NTD-NRC-96-4622
DCP/NRC0447
Docket No.: STN-52-003

SUBJECT: WESTINGHOUSE RESPONSES TO NRC REQUESTS FOR ADDITIONAL
INFORMATION ON THE AP600

RAI's addressed in the January 12, 1996 submittal:

Figure 440.286-7 C064506 Test, CMT Outlet Fluid Temperature

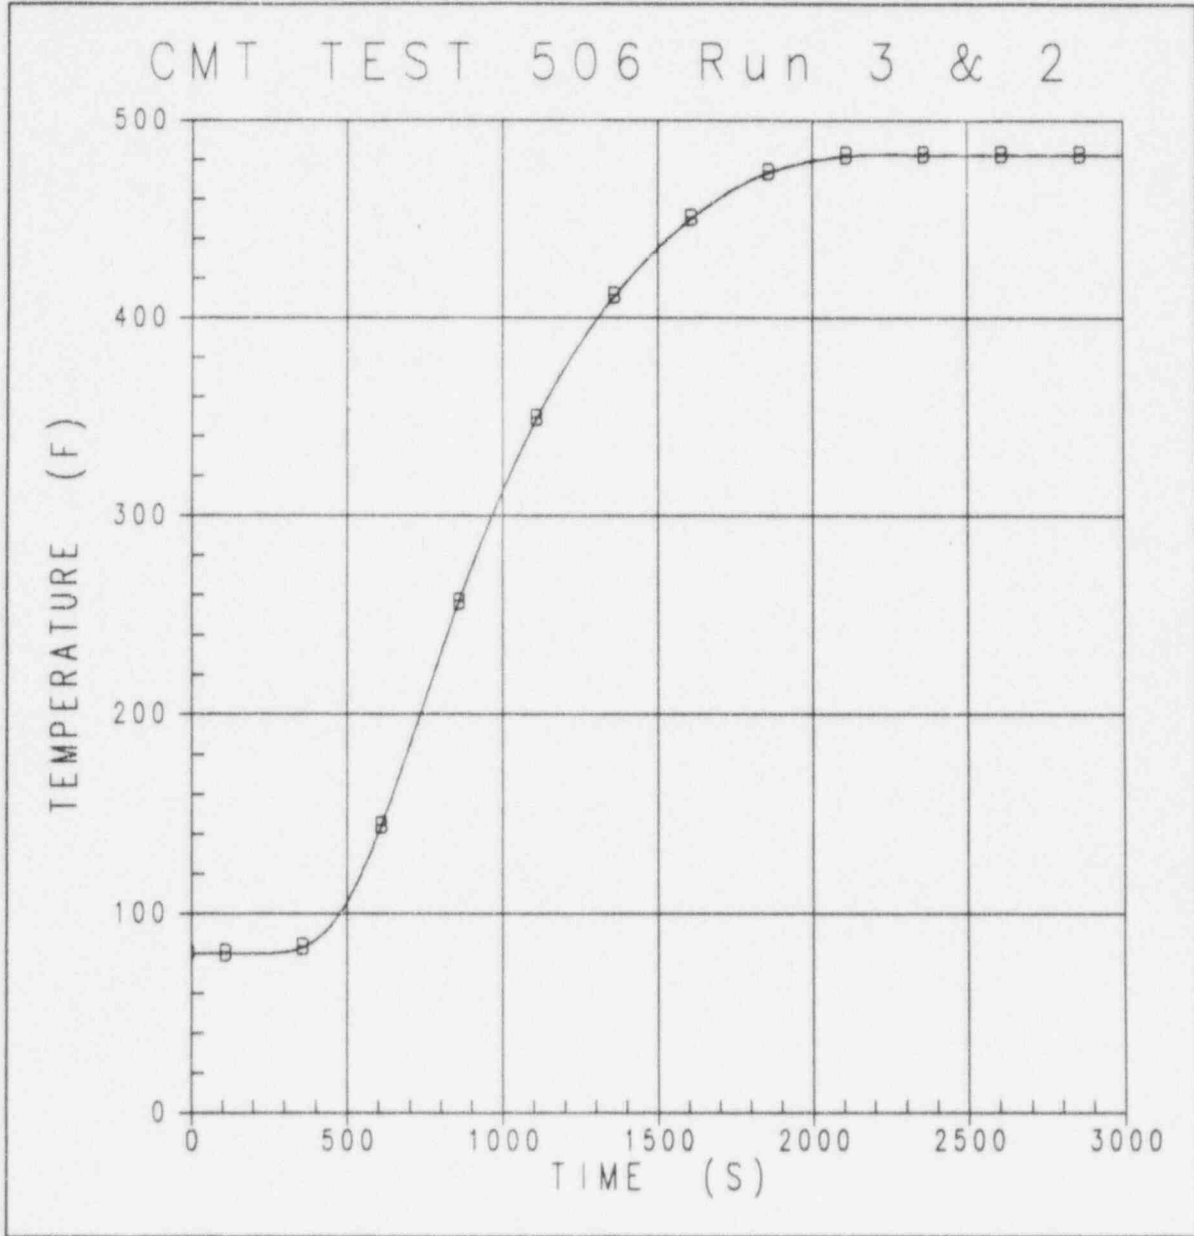
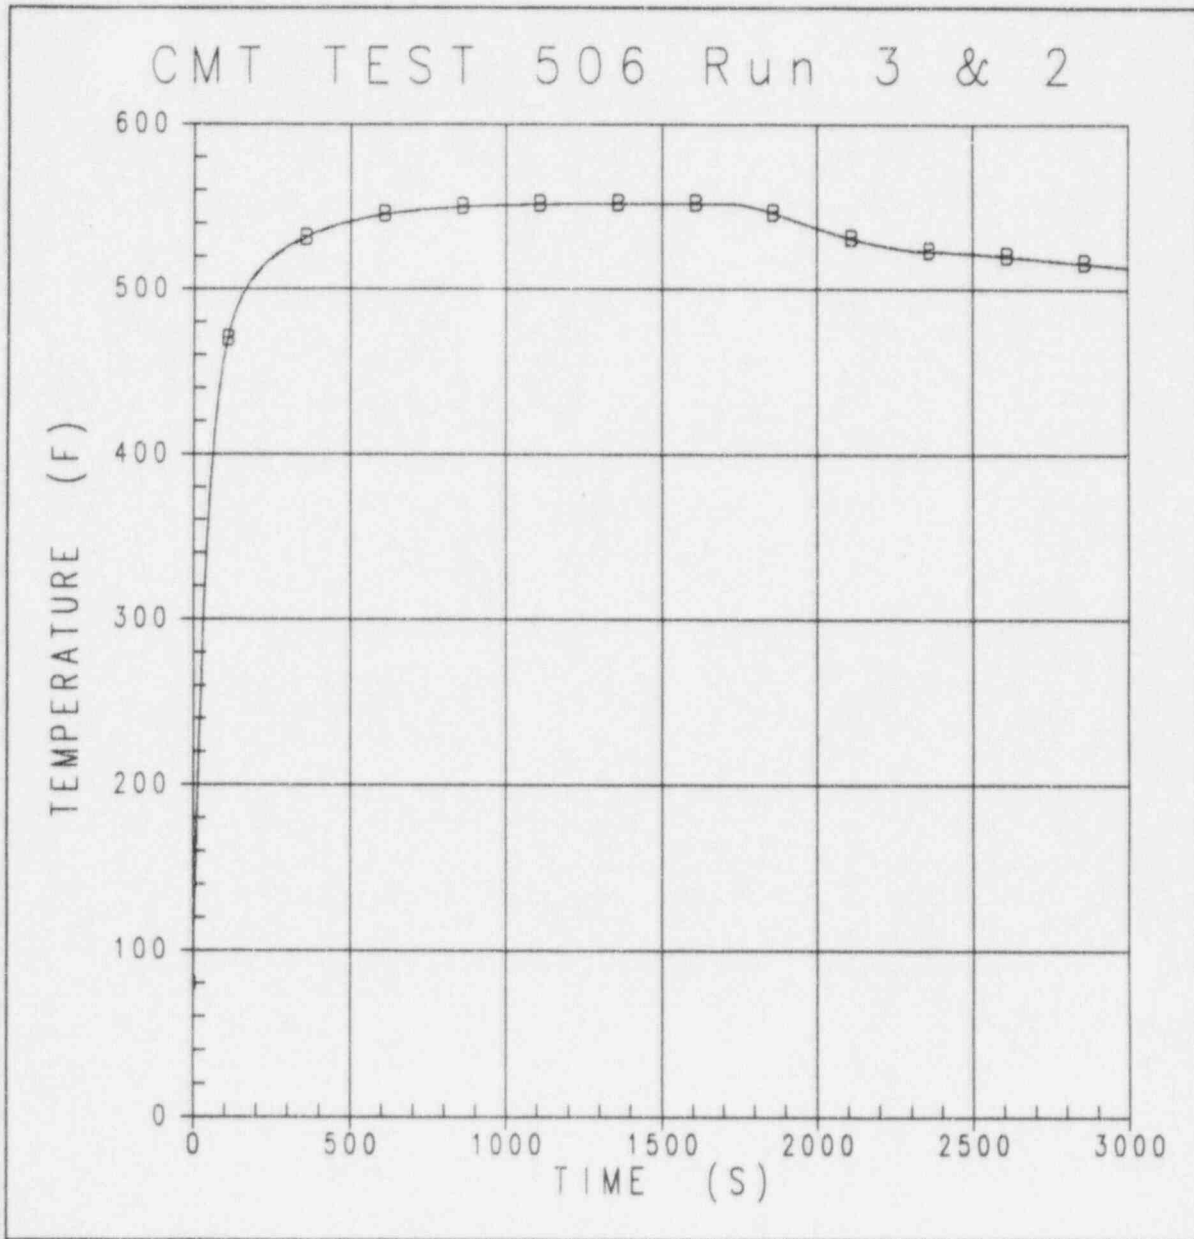
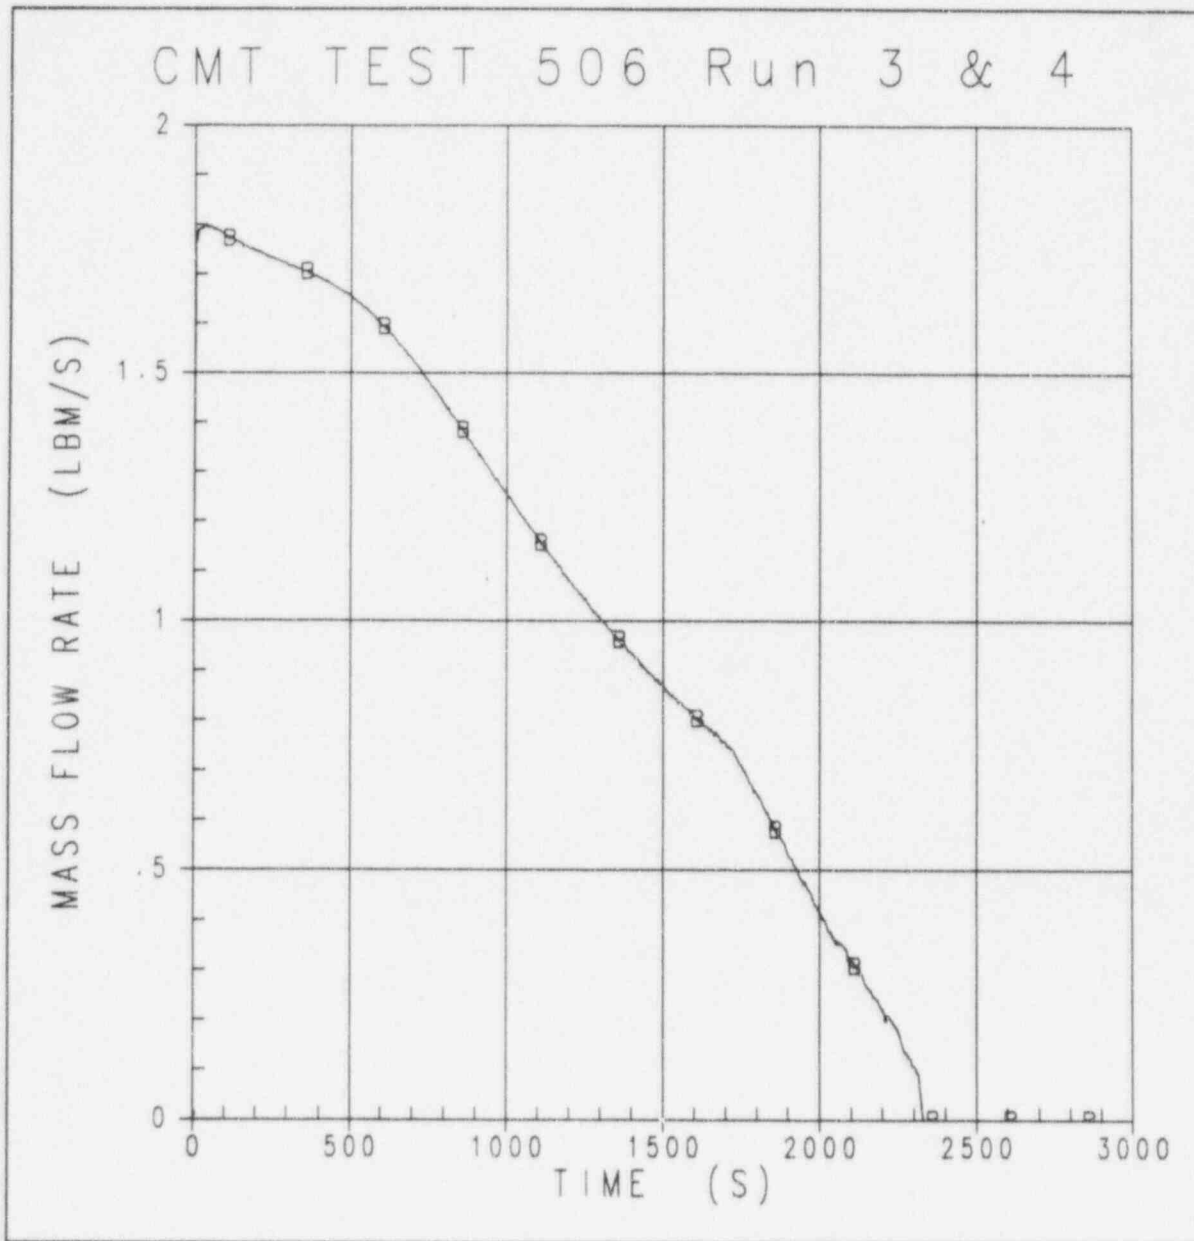
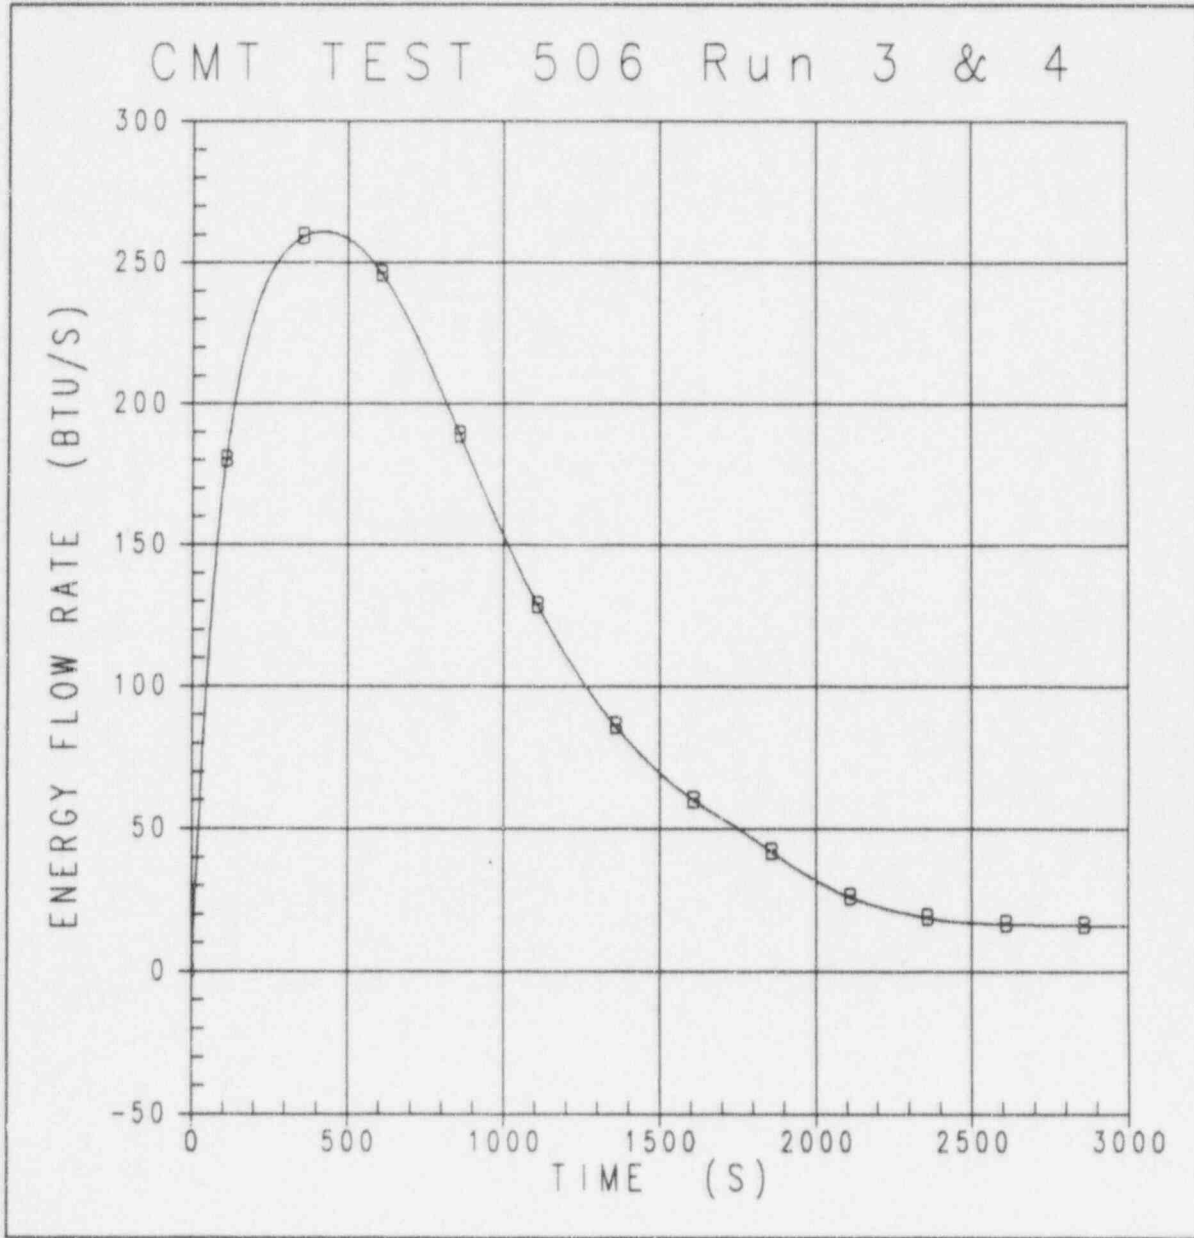
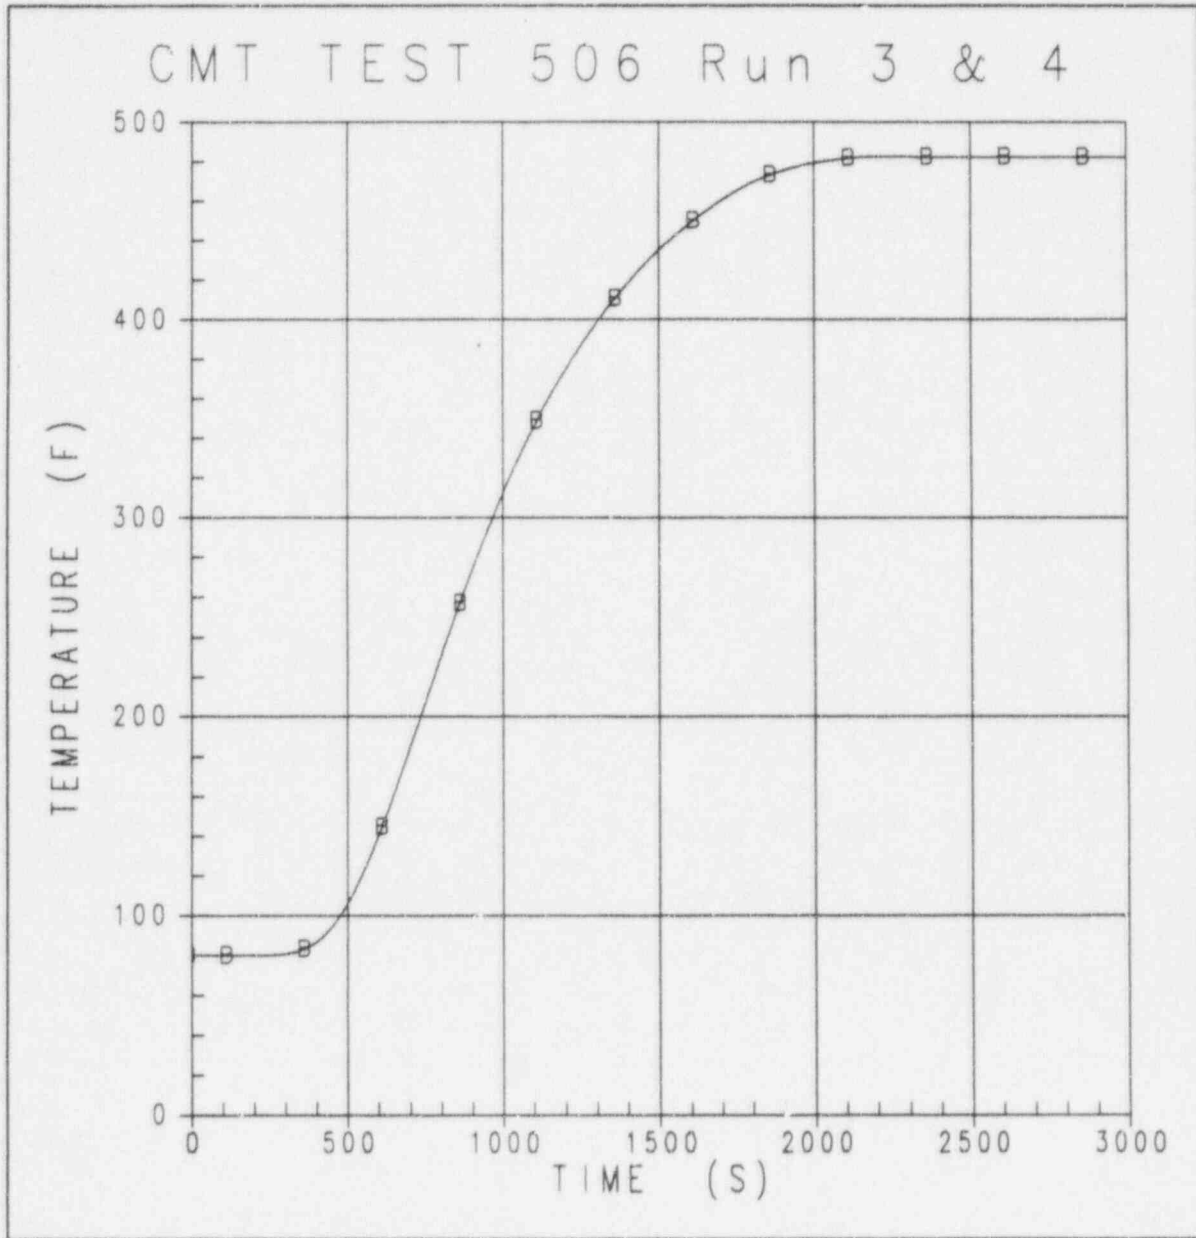
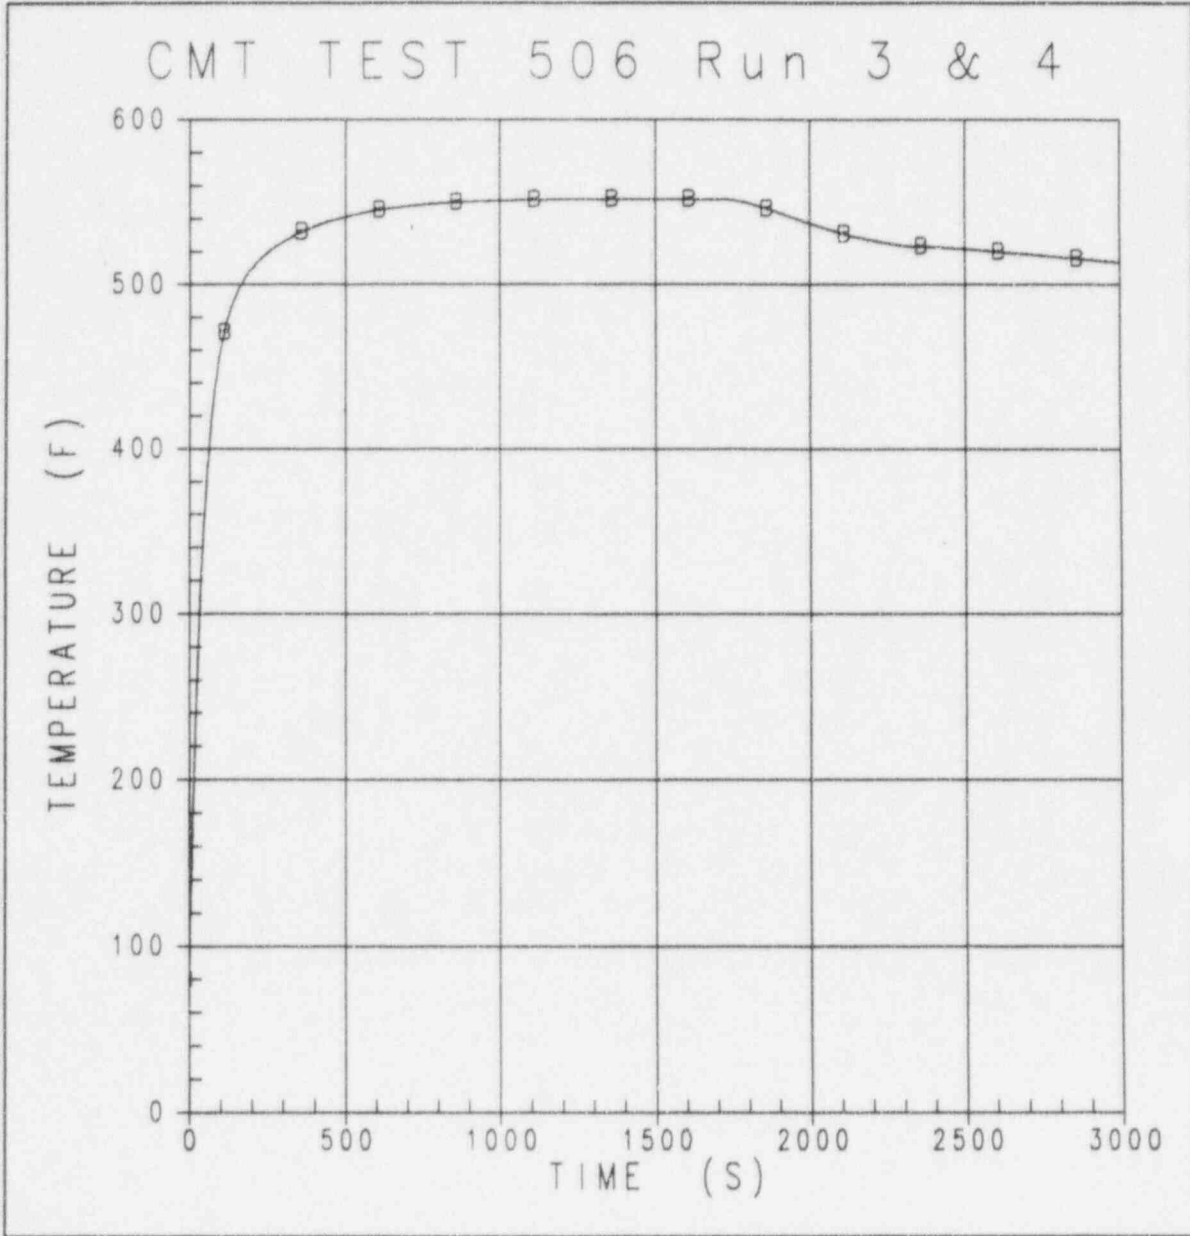
Section 3.1, page 3-1. Please provide a stability analysis of the CMT model that determines the time step bounds for the CMT. Also, please show how the stability of the model is affected by any explicit connection to the RCS.

Figures 440.286-1 through 440.286-12 provide the key parameters for each run. Run 3 is selected as the base case and the other runs are compared to this base case.

The comparison of Run 3 with Runs 2 and 4 (Figures 440.286-5 to 440.286-12) shows that the CMT module response is independent of the CMT time step for time steps less than 2.5 seconds. The plots are superimposed and it is almost impossible to differentiate the results. This demonstrates that the LOFTRAN CMT numerics are stable when used within the acceptable time step range. This is always the case for the AP600 SSAR analyses performed using LOFTRAN-AP or LOFTTR2-AP.

Figure 440.286-1 shows that the CMT model is not stable with a time step of 5 seconds, especially between time zero and 1000 seconds. The injection flow rate oscillates around the solution of run 3. The flow oscillations have a small impact on the other parameters (Figure 440.286-2, 440.286-3, and 440.286-4). This proves that the limiting equation with respect to time step stability is the momentum equation of the lines connecting the RCS and CMTs which is solved explicitly (see response to RAI 440.285).
